Classification:
EM21-002AReference:
ITB21-020ACOPYRIGHT© NISSAN NORTH AMERICA, INC.
Date:
March 11, 2022

FUEL AND/OR OIL SMELL IS PRESENT WHEN THE VEHICLE IS PARKED IN A CLOSED GARAGE

APPLIED VEHICLES: 2019-2021 QX50 (J55)
2022 QX55 (FJ55)

Figure 1

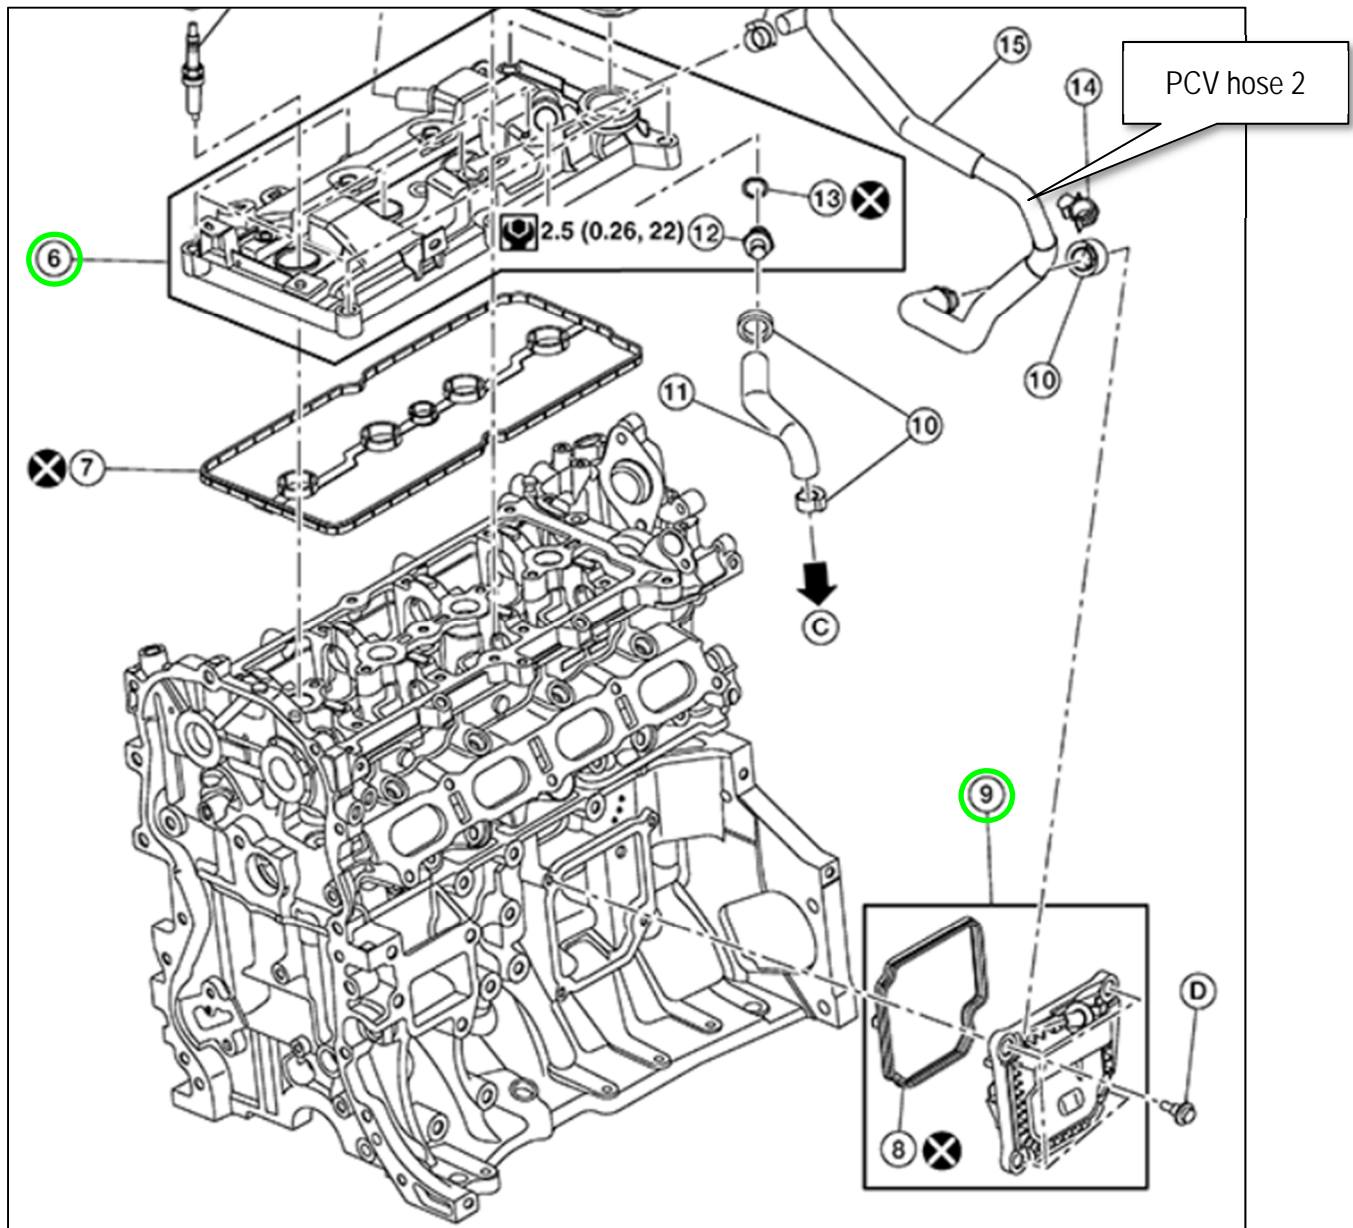
Replace the rocker cover assembly and the PCV separator with those listed in the **PARTS INFORMATION**, and eliminate PCV hose 2.

1. Replace the rocker cover assembly (number 6 in Figure 1) with the one listed in the **PARTS INFORMATION**.
 - Refer to the ESM, section **ENGINE > ENGINE MECHANICAL > KR20DDET > REMOVAL AND INSTALLATION > ROCKER COVER**
2. Replace the PCV separator (number 9 in Figure 1) with the one listed in the **PARTS INFORMATION**.
 - Refer to the ESM, section **ENGINE > ENGINE MECHANICAL > KR20DDET > REMOVAL AND INSTALLATION > PCV SEPARATOR**

NOTE: PCV hose 2 (number 15 in Figure 1) is no longer required with the parts listed in the **PARTS INFORMATION**.

DESCRIPTION	PART NUMBER	QUANTITY
Rocker Cover Assembly	13264-5NA2A	1
Rocker Cover Gasket	13270-5TA0A	1
PCV Separator	11830-5NA1A	1
PCV Separator Gasket	13270-5NA0A	1
Intake Manifold Gasket	14035-5NA0A	4
Nissan Long Life Coolant	999MP-L25500P (1)	As needed
